Re: Draft Final Remedial Action Work Plan  
LHAAP-16 Landfill  
Final Record of Decision September 2016  
Longhorn Army Ammunition Plant, Karnack, Texas

**Response to Comments on  
Draft Remedial Action Work Plan, LHAAP-16 Landfill  
Longhorn Army Ammunition Plant, Karnack Texas**

TCEQ Comments on Draft Remedial Action Work Plan, LHAAP-16

*Draft Final*  
**Remedial Action Work Plan,  
LHAAP-16 Landfill**  
Longhorn Army Ammunition Plant  
Karnack, Texas

Figure 4-2  
 MNA and LTM Monitoring Plan  
 LHAAP-16 RAWP  
 LONGHORN ARMY AMMUNITION PLANT  
 KARNACK, TEXAS

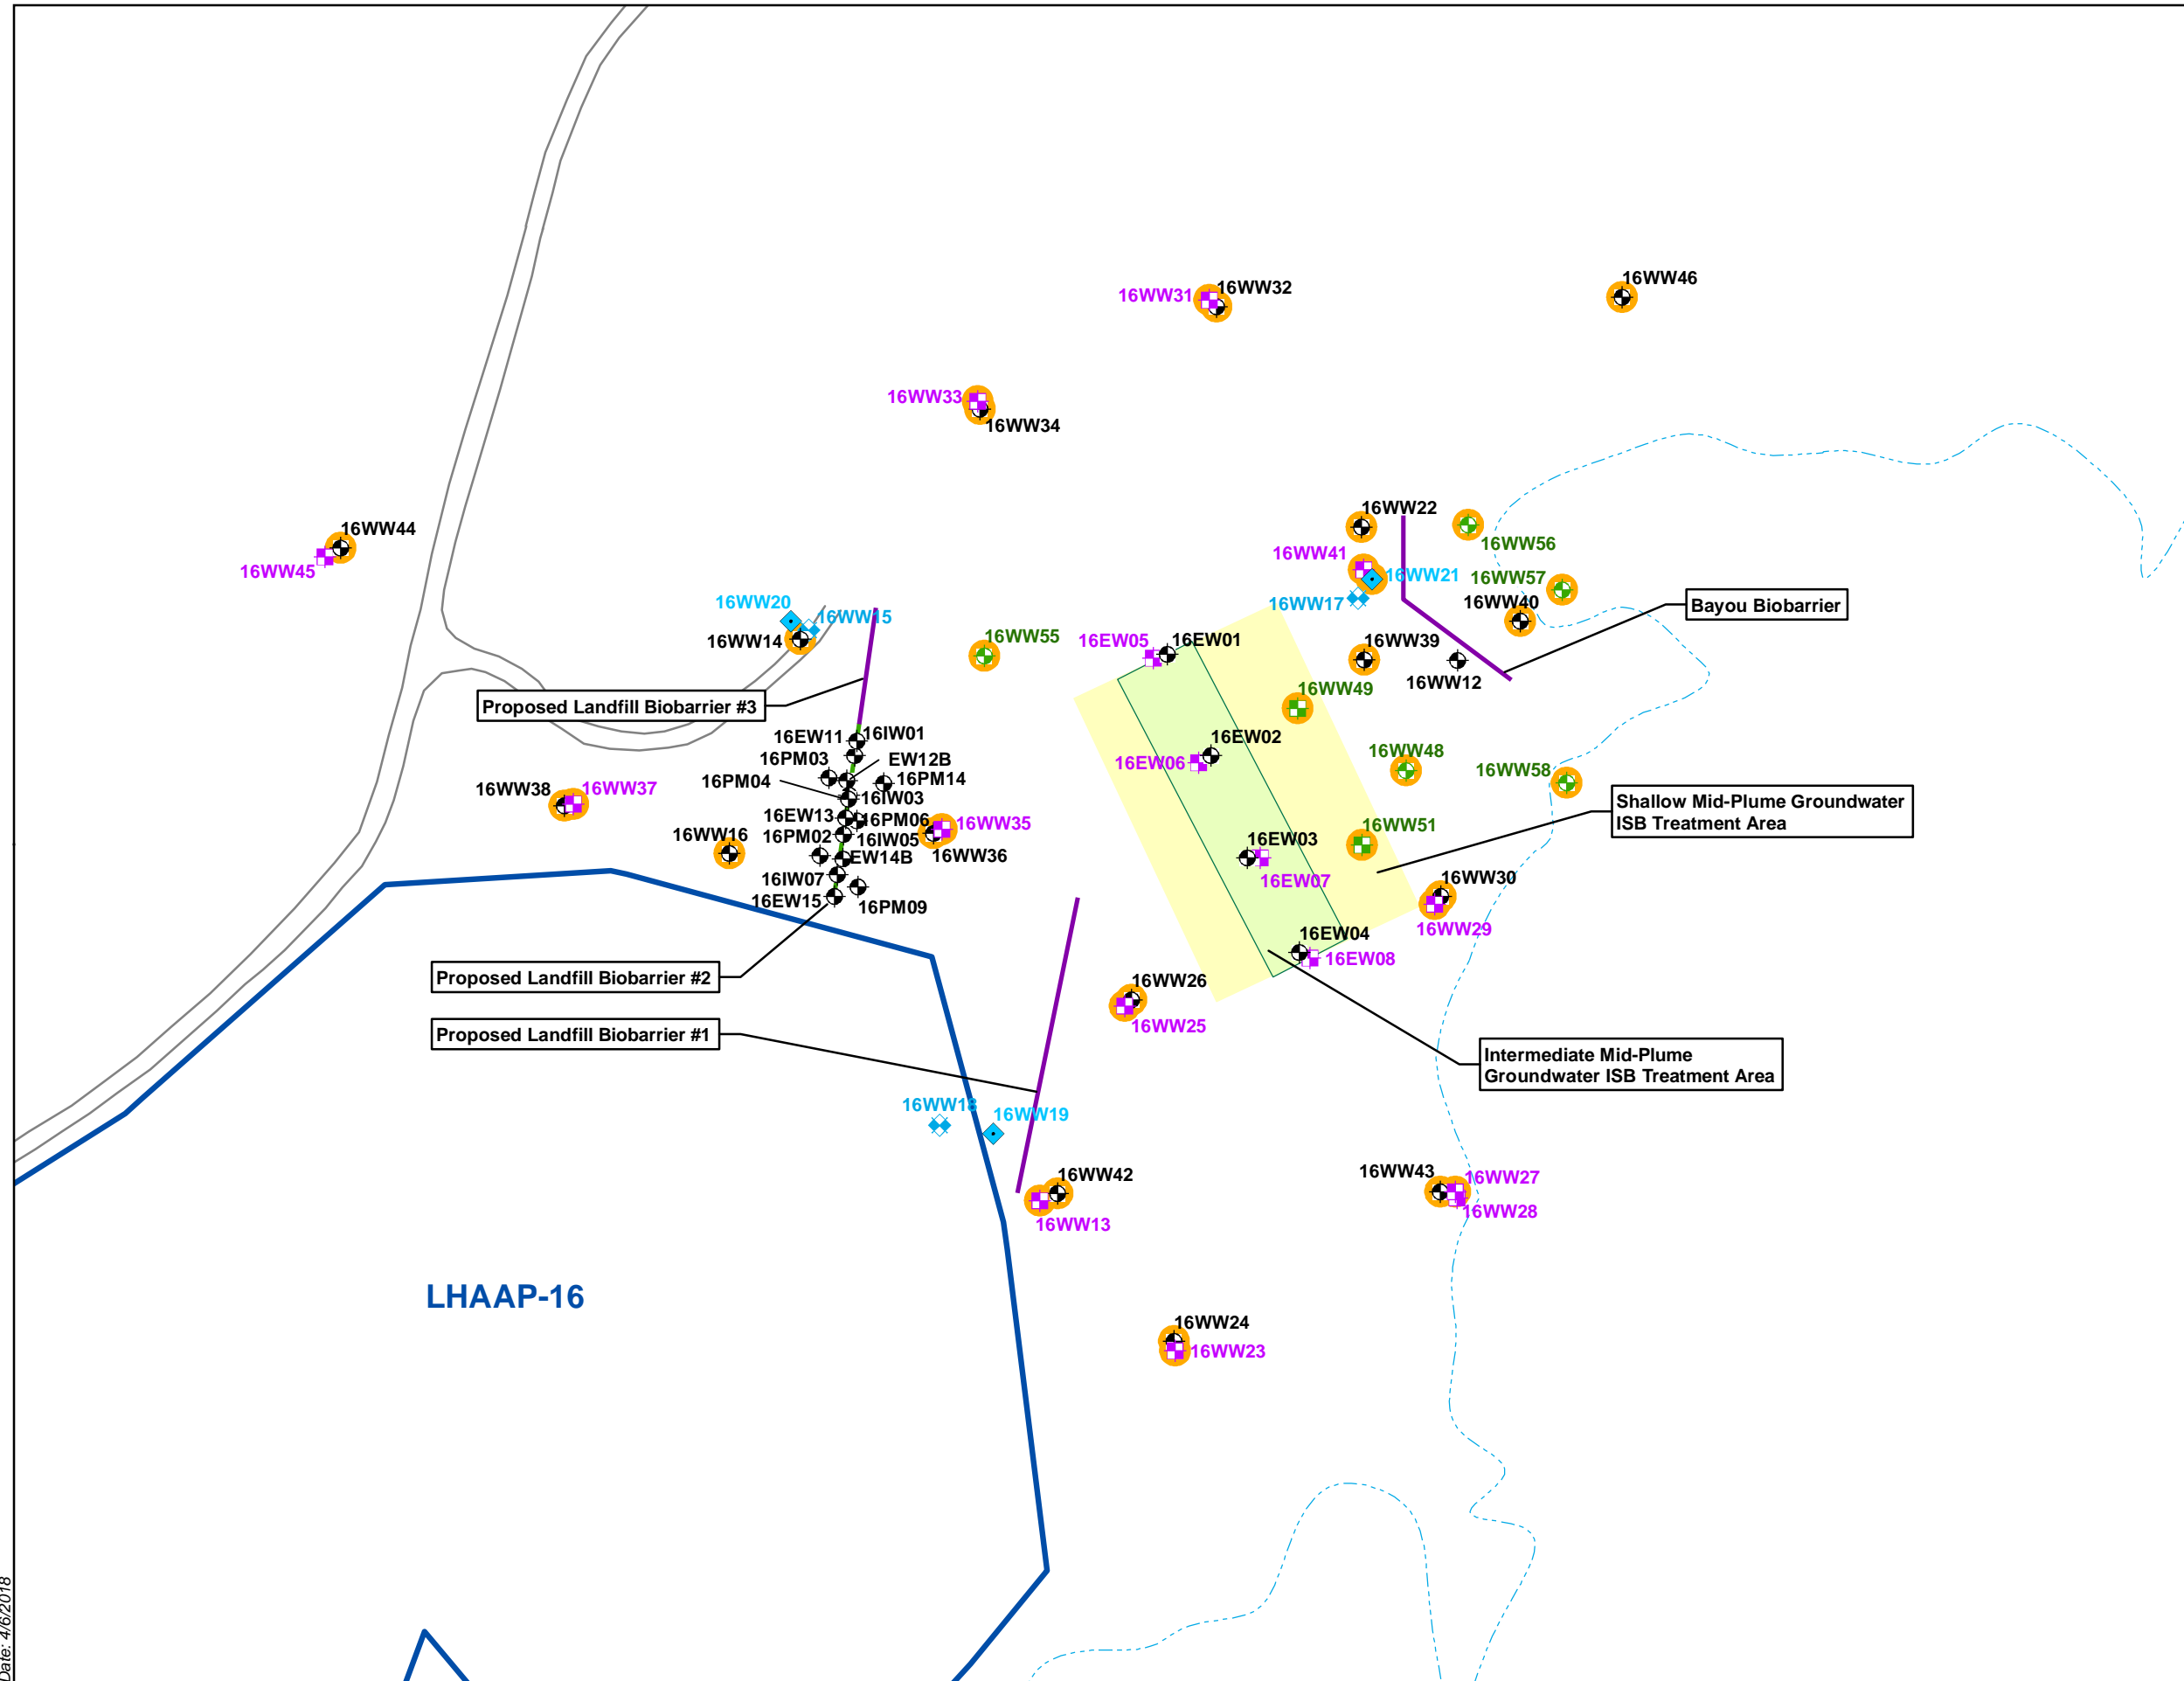
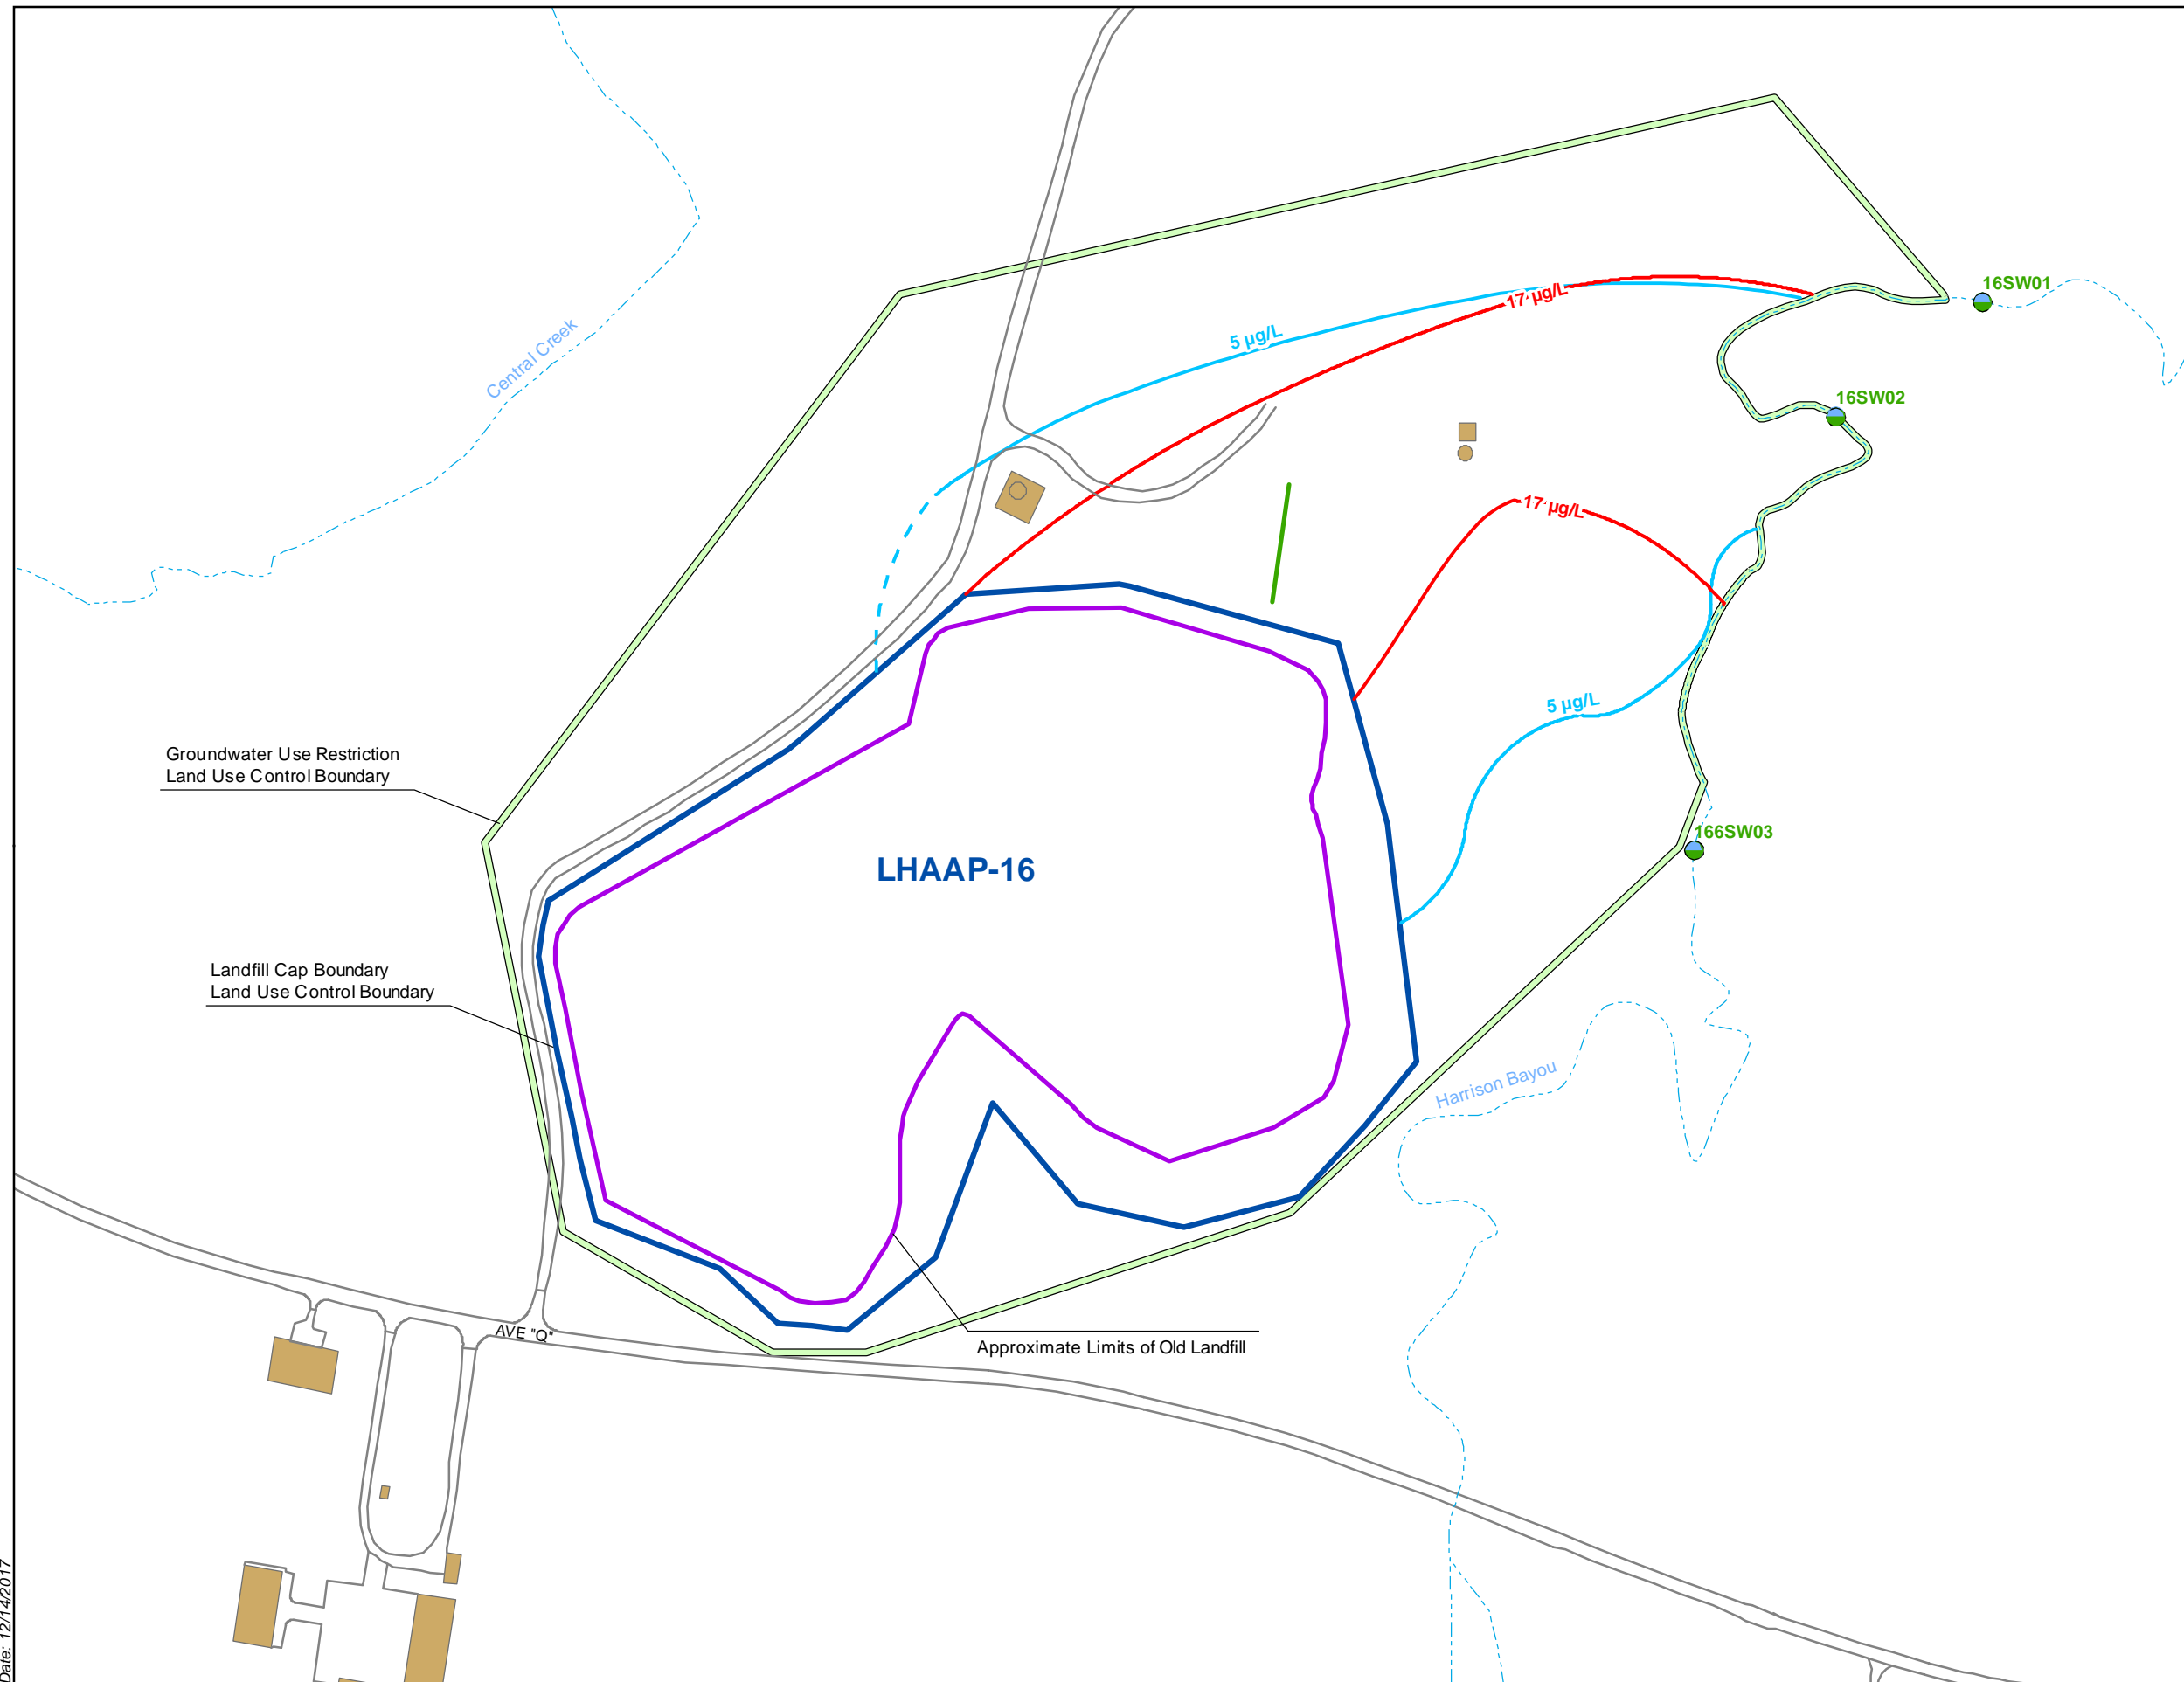
15.	Page 4-12, Section 4.7.5	The text indicates that Figure 4-3 shows locations of wells for monitoring, but the figure is for surface water collection locations. Please revise to Figure 4-2.	C	Concur. Text will be revised to reference Figure 4-2.	A

18.	Figure 4-2	Intermediate wells or potentially even deeper wells may need to be drilled on the east side of the bayou due to the intermediate zone contamination currently on the east side of the bayou at monitoring well 16WW41 at 6,650 µg/L of TCE. There is potential for additional migration to the northeast for the intermediate zone.		Noted. EPA made this similar comment during the RD review indicating that a well might be needed at some point in the future. However, at this time, no plans for an intermediate zone well on the east side of the bayou have been made until additional data is collected as part of the implementation and monitoring of the in situ bioremediation. See below for EPA’s comment 17 from the review of the Remedial Design.  <i>“EPA agrees with the additional shallow wells proposed by TCEQ shown on revised Figure 4-1. Also, EPA recognizes there may be a need for additional Intermediate groundwater monitoring wells in the future, especially in the outer eastern reaches of the plume.”</i>	A	Evaluation of the data obtained during and after the implemented treatments should provide insight for any future actions.

Figure 4-3  
Surface Water Sampling Locations  
LHAAP-16 RAWP  
LONGHORN ARMY AMMUNITION PLANT  
KARNACK, TEXAS

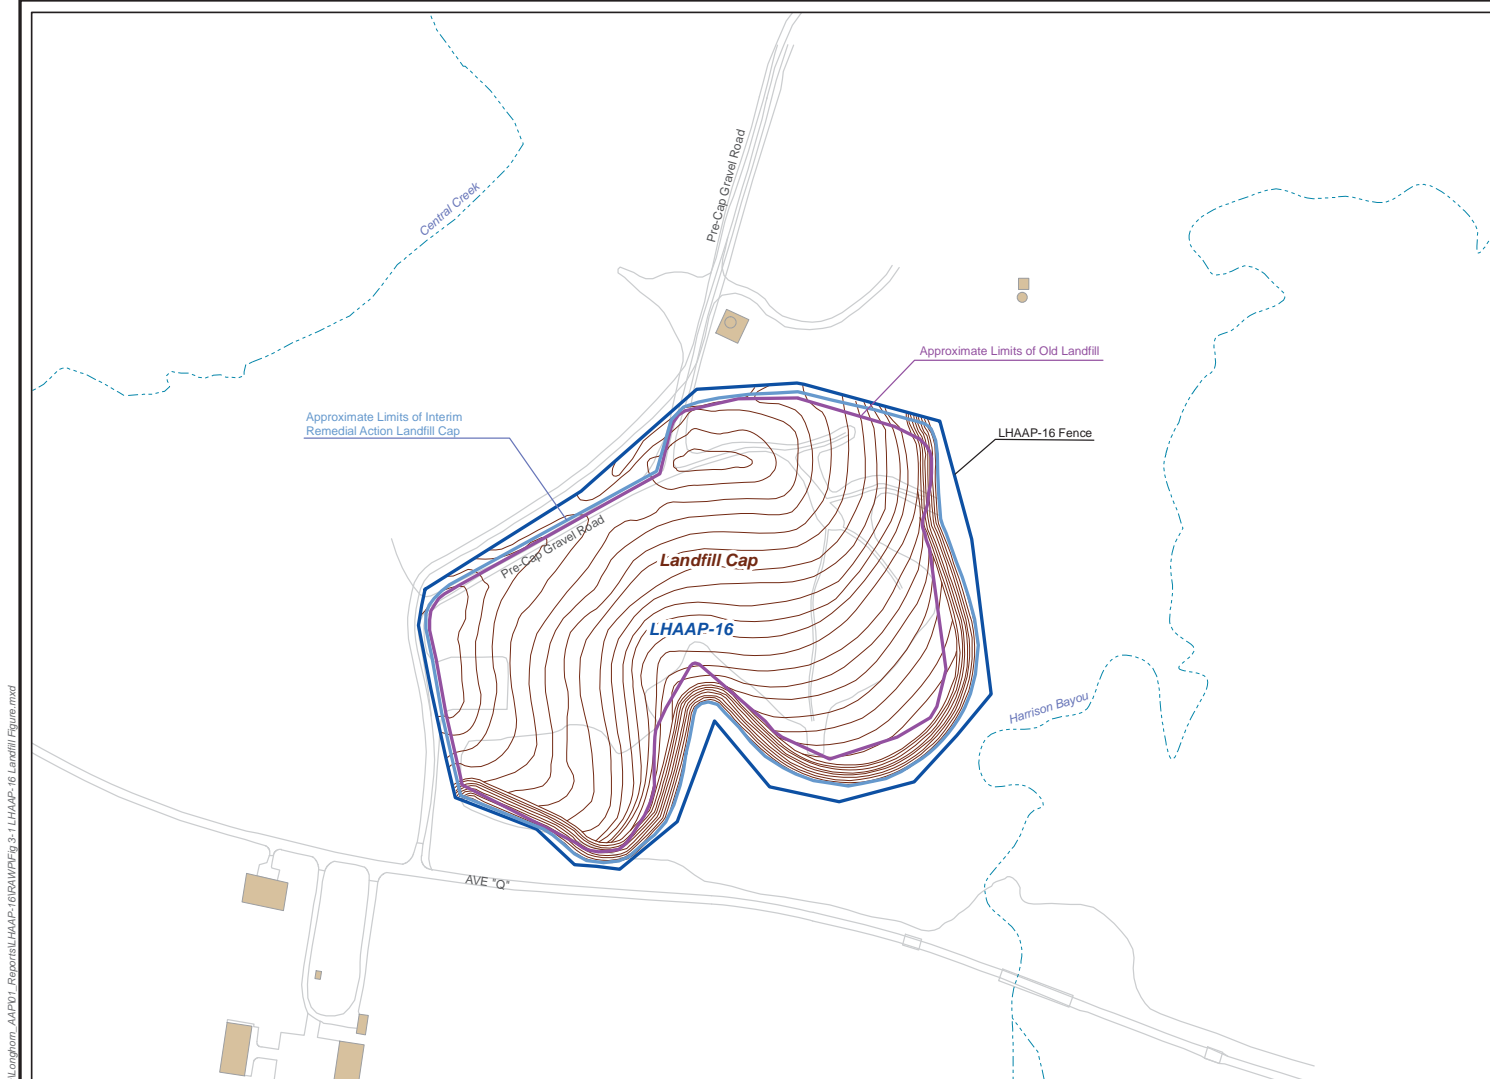
17.	Page 4-2, Item 4	Please identify where the baseline surface water samples will be collected and what constituents/parameters will be analyzed (in regards to potential injection leakage). EPA recommends moving surface water location 16SW02 more towards the left bend in Harrison Bayou based on where TCE was found in shallow groundwater (see Appendix A, Figure 2-6 and well number 16WW40, 1060 µg/L).		<p>Pre-remedy surface water samples will be collected from 16SW01, 16SW02, and 16SW03. Samples will be analyzed for VOCs, perchlorate and metals. Additionally, field measurements (DO, ORP, pH, temperature, and conductivity) will also be collected. The surface water sampling plan is included in a new Table 4-10 (an attachment to TCEQ’s RTCs).</p> <p>The location for 16SW02 was established in the EPA and TCEQ approved Final RD.</p> <p>Text in Section 4.2.1, bullet 4 will be revised as follows:</p> <p>“...as indicated in <b>Tables 4-2 and 4-3</b>. Collect pre-remedy surface water samples from three</p>	A	EPA recommended the alternate location because it was close to the location of observed seeps identified in the past at Harrison Bayou.
